**SOUTHERN NEVADA PROPOSED AMENDMENTS
TO THE
2024 INTERNATIONAL BUILDING CODE
FIRE AND LIFE SAFETY COMMITTEE**

International Building Code - Fire & Life Safety Code Committee
Revised January 27, 2024

SOUTHERN NEVADA CODE AMENDMENT FORM – 2024

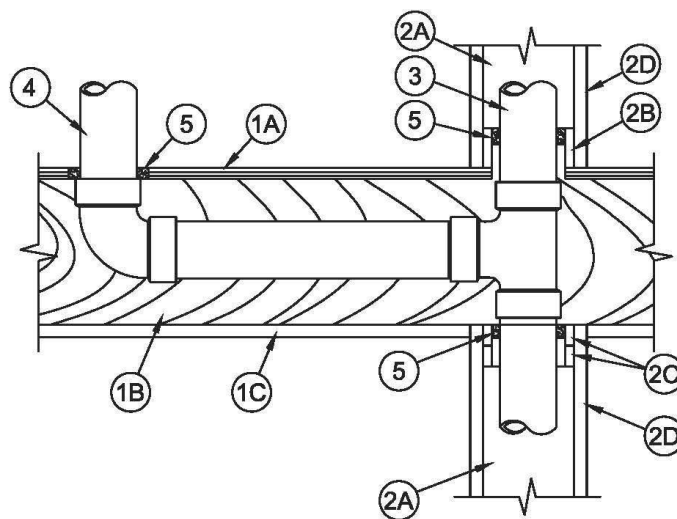
The current code language merely requires a “double wood top plate”. As currently written, the top plate could consist of two ½” plywood strips or two 4x8s with no regard to the ability of the material to resist fire. The fact that a clarification statement needed to be added to the code commentary for this item is a clear indication this section needs to be revised. It is important to clarify exactly what the minimum is to achieve the continuity of the membrane rating at the penetration. This code change would allow for a single 2x top plate or a combination of a single 2x top plate with a 1x top plate as a minimum to add clarification to the section.

An additional reason for this change is to allow for current construction methods. Standard construction methods in wood construction require a gap to be placed between the bottom of the floor joists or truss and the top of a non-bearing partition. This allows for deflection of the truss without adverse loading from interference of a non-bearing partition. The standard method for creating this gap is to use a single 2x top plate with a 1x top plate to create a double top plate. Bearing walls and exterior walls are already required to use a double 2x top plate per IBC section 2308.9.3.2 and therefore are not generally affected by this code clarification.

Compliant nailing of the gypsum board can be maintained with a single 2x top plate. In a 1-hour assembly with a single layer of drywall, a single 2x top plate is sufficient to achieve drywall nailing. The standard 2x is 1 ½” thick. If you remove 5/8” for drywall, you are left with 7/8” of plate width for nailing. The required edge distance of a fastener in gypsum board is 3/8” per IBC Section 2508.6.3 allowing an edge distance of ½” on the plate. A standard joint at a stud in a fire rated wall would require 3/8” edge distance for each gypsum sheet leaving only 3/8” edge distance on each side of the stud. This shows that the proposed top plate configuration allows more nailing width than is required in the fire rated assembly.

In a 2-layer assembly, compliant nailing can be achieved with a 2x top plate with a 1x top plate. A 2x, which is 1 1/2", and a 1x, which is 3/4", will achieve a total top plate thickness of 2 1/4". If one subtracts 1 1/4" for 2 layers of 5/8" gypsum board from 2 1/4", there is 1" remaining. This will allow for 3/8" edge distance on the gypsum sheet as well as 5/8" edge distance on the top plate. This is also in excess of the minimums required for fire rated assemblies.

The 2x with a 1x plate application will also work with resilient channel (RC) and a single layer of gypsum board. The RC is 1/2" plus the 5/8" gypsum board for a total of 1 1/8" leaving 3/4" of edge distance on the top plate after subtracting the 3/8" drywall edge distance. This would even allow for a full 3/4" RC without degrading the fire rating of the assembly.

The order of nailing can also be modified to provide even more edge distance. If the wall sheathing is nailed first, the installer could take full advantage of the entire top plate thickness for edge distance. The ceiling membrane could then be butted tightly to the wall sheathing to achieve the rating. This configuration is demonstrated in U.L. listed assembly system number F-C-2387.

FULLY SPRINKLERED BUILDING
FULLY DUCTED HVAC

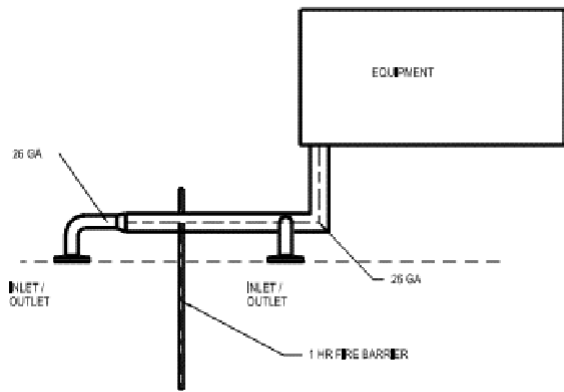
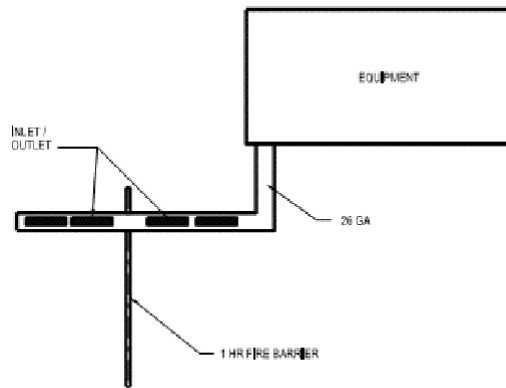
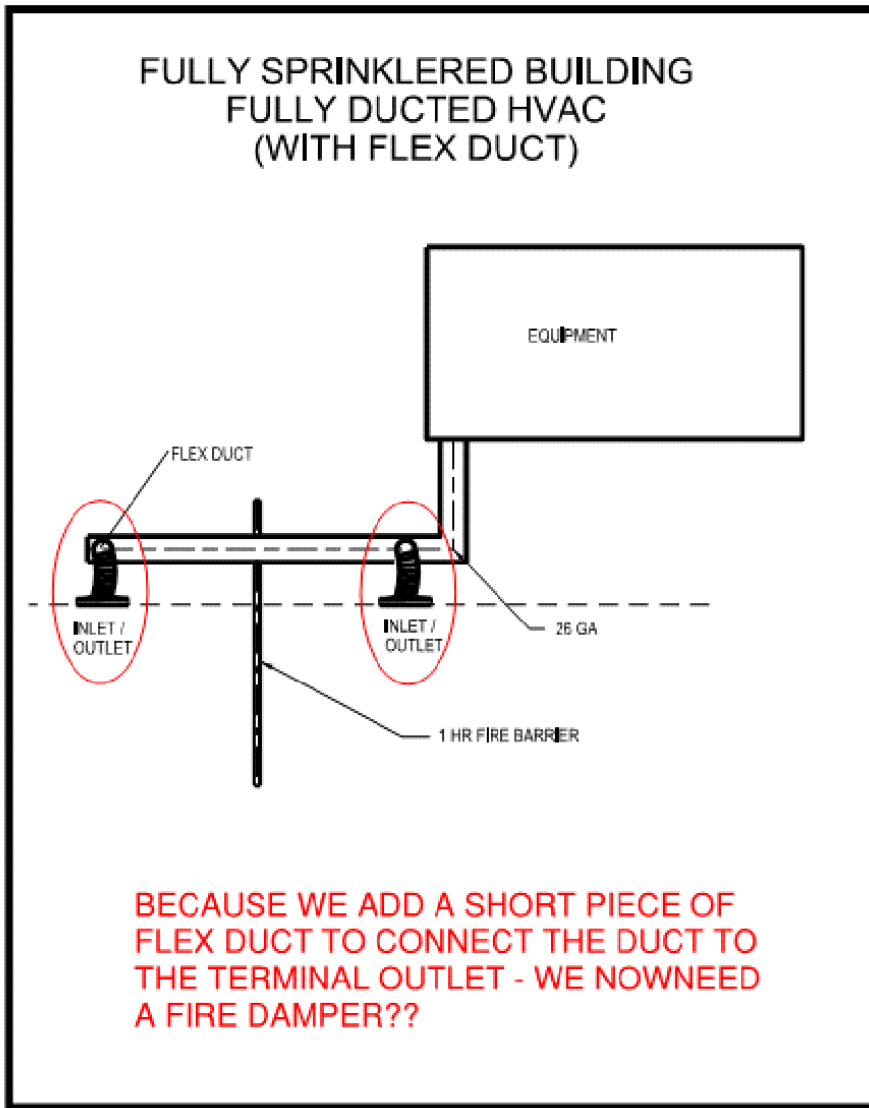
The code language as currently written would allow for a duct to have openings on either side of a fire-resistant wall with no limitations. If duct openings were directly adjacent to the wall on both sides of the assembly, fire could potentially use this path to ignite materials on the opposite side of the assembly, negating its ability to resist the passage of fire. Requiring a minimum separation of duct terminals would limit the ability of fire to use the terminal openings to transfer from one side of the fire-resistant wall to the other.

The inclusion of the non-metal flexible air connectors is to accurately reflect the typical installation. As currently written, the code allows for duct terminals on the metal duct without having to require *fire dampers*. The addition of a flexible duct connector to go from the metal duct to the ceiling terminal would require the use of a *fire damper* at the *fire partition*. Addition of a flexible duct connector in this case does not add to the fire risk of the assembly and should not require additional protection. This language is consistent with the language for *fire barriers* in Section 717.5.2 exception 3 that was adopted to the 2021 IBC under item FS67-18.

The attached exhibits show what is currently allowed per the code. As shown in the first exhibit, there is no limit in the location of the openings in the duct for terminals where no fire damper is required. The second exhibit shows that adding the flexible connector, no matter how far from the fire-resistant wall it is, would require a damper to be added.

4.2. From an overhead metal duct to a ceiling diffuser within the same room in accordance with Section 603.4 of the *Uniform Mechanical Code* where the connection point to the metal duct is not within 6'-0" of the fire rated assembly.

Condition 1: Adjacent lot lines or to the centerline of a street, an alley or public way.

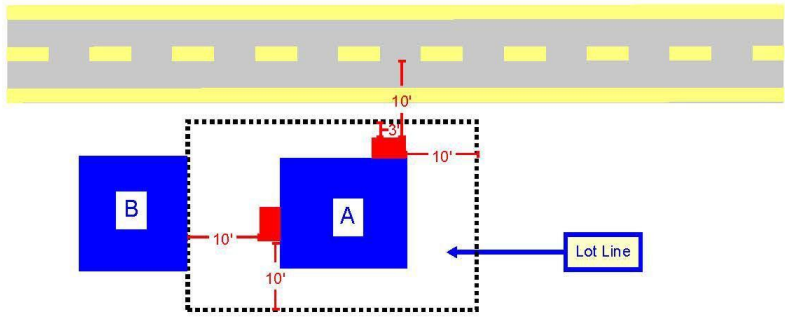
Item 1 was clarified to permit the minimum separation distance to be measured to the centerline of the street, alley, or public way. Exterior exit stairways should not be limited based on the lot line where facing a street. The IBC Code Commentary specifies that the reason a minimum 10 ft separation distance is required to an adjacent lot line is in case a future building is built right on an adjacent lot. Where the lot line faces a street, alley, or public way, the hazard of a building being built right on the adjacent property line is omitted, therefore, the separation distance should be measured to the centerline of the street, alley, or public way similar to how fire separation distance is measured.

Items 2 and 3 were revised to clarify the difference between the separation distance of IBC 1027.5 and fire separation distance. The separation distance of IBC 1027.5 specifically does not reference an imaginary lot line for separate buildings on the same lot. Item 3 addresses separate buildings on the same lot and states that the distance shall be measured perpendicular from the exterior exit stairway to the adjacent building and not an imaginary lot line. A total distance of 10 ft. between buildings is an adequate distance to maintain a safe non-rated egress path. This is further supported by the requirements of egress courts which require a minimum 10 ft. width to have non-rated egress court walls. This was simplified to indicate the minimum 10 ft separation shall be measured to other portions of the building and buildings on the same lot. An exception was added to clarify that where separate buildings on the same lot are protected in accordance with IBC 705 based on fire separation distance the minimum 10 ft separation distance is not required.
